2015 SOUTH GATE EDUCATIONAL CENTER MASTER PLAN SUPPLEMENTAL FINAL ENVIRONMENTAL IMPACT REPORT

NOVEMBER 2016

SUPPLEMENTAL FINAL ENVIRONMENTAL IMPACT REPORT

- Supplemental Draft EIR page 4.6-7, replace **Figure 4.6.3**.

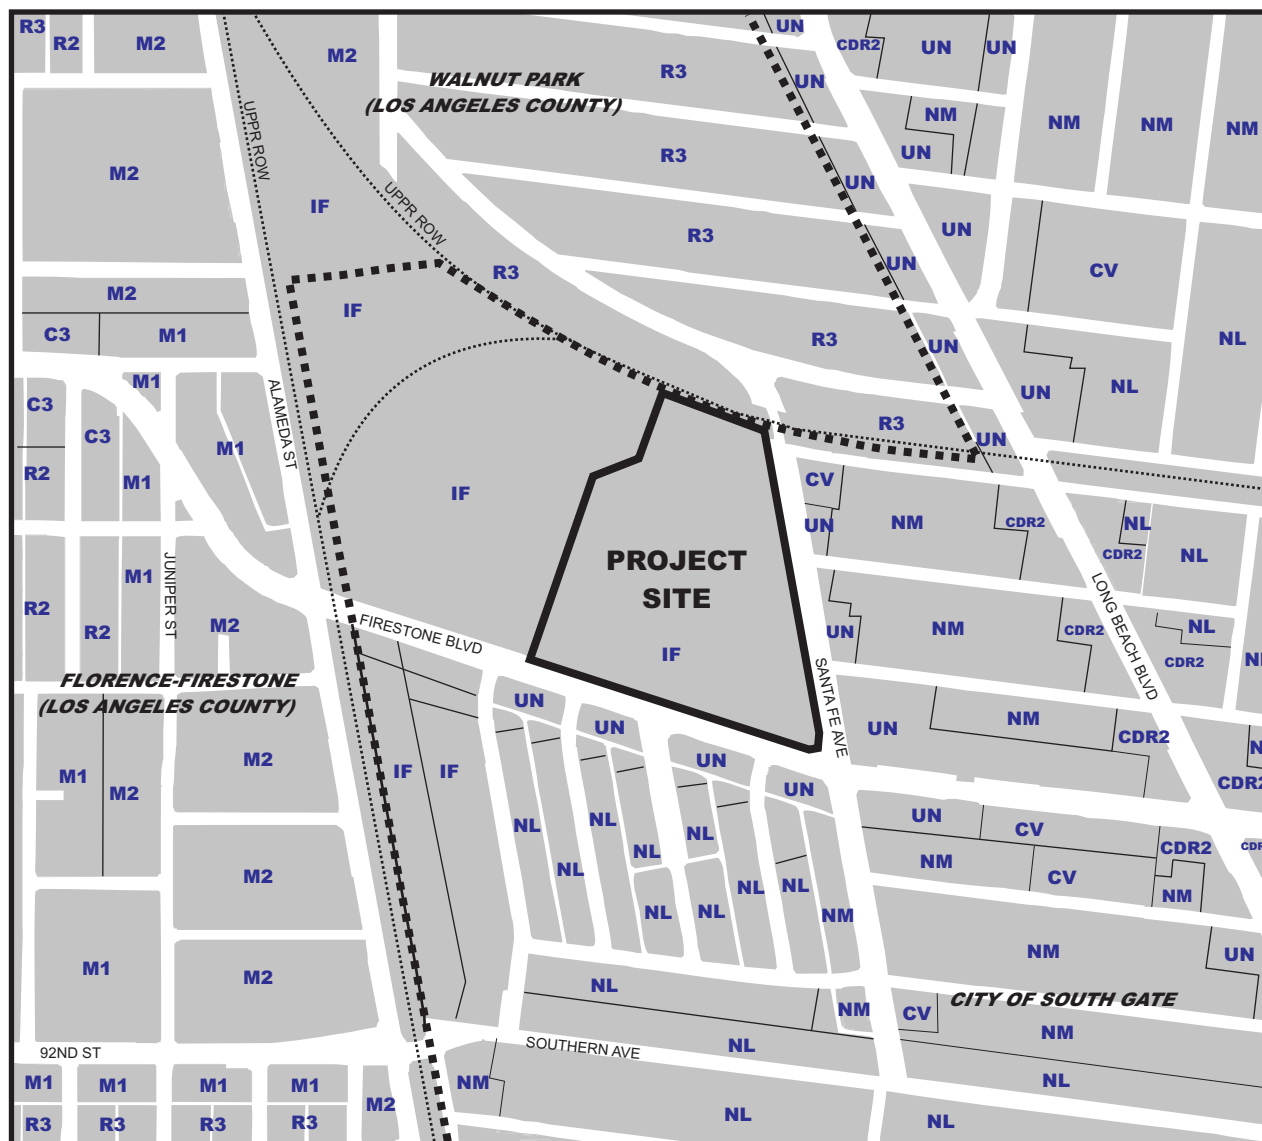
- Supplemental Draft EIR page 4.6-7, 1st paragraph, revise as follows:

City of South Gate Comprehensive Zoning Code (CZC). Title 11 of the South Gate Municipal Code (SGMC) contains the CZC. The CZC serves as the primary implementation tool of the General Plan. The General Plan is a policy document that sets forth direction for development decisions and the CZC is a regulatory ordinance that establishes specific standards for the use and development of all properties in the City. The CZC regulates development intensity using a variety of methods, such as setting limits on building setbacks, yard landscaping standards, and building heights. The CZC also indicates which land uses are permitted in the various zones. As shown in **Figure 4.6-3**, the zoning designation for the project site is ~~Heavy Manufacturing (M-3)~~ Industrial Flex (IF). ~~The Heavy Manufacturing (M-3) zoning designation allows for high intensity manufacturing uses, as well as lower intensity manufacturing uses categorized under the light manufacturing (M-2) and commercial manufacturing (C-M) zoning designations. Institutional land uses are permitted under all three of these industrial zoning designations. The Industrial Flex zone permits Traditional College campuses by Conditional Use Permit (CUP) and Non-Traditional College's campuses are permitted as a primary use subject to compliance with all applicable provisions of the Zoning Code, subject to first obtaining a Code Compliance Certificate. The CZC defines a Traditional College Campus as a college in a traditional multi-building campus setting for educational purposes and providing faculty offices, student services, and on-campus student housing. A Non-Traditional College campus is defined as a college in a business/office-oriented setting that does not include any form of student housing.~~

See updated **Figure 4.6.3**.
